Access Compliance Report

Public Rights-of-Way

(Curb Ramps)

| Intersection ID: 21478 | Main Street: KILCULLEN_DR | Cross Street: N/A | Location: NE |

| ADA ID: E0F62FCF7E35 | Ramp Type: PerpDiag | Initial Pass/Fail: Fail | Overall Compliance: No |

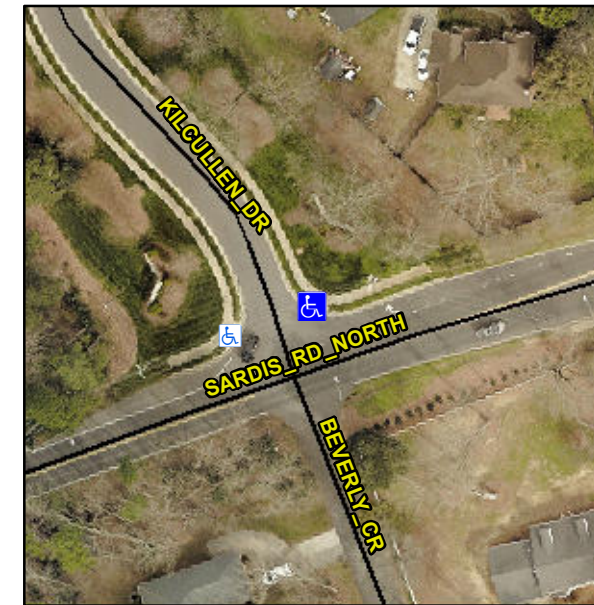
Not Found, R304.5.3

| Compliance | Description | Data | Compliance | Description | Data |
|------------|-----------------------|------|------------|-----------------------------|------|
| Yes | Ramp Width (in) | 48.0 | No | Ramp XSlope (%) | 5.5 |

Remove & Replace Curb Ramp With Two New Directional Ramps or Equivalent.
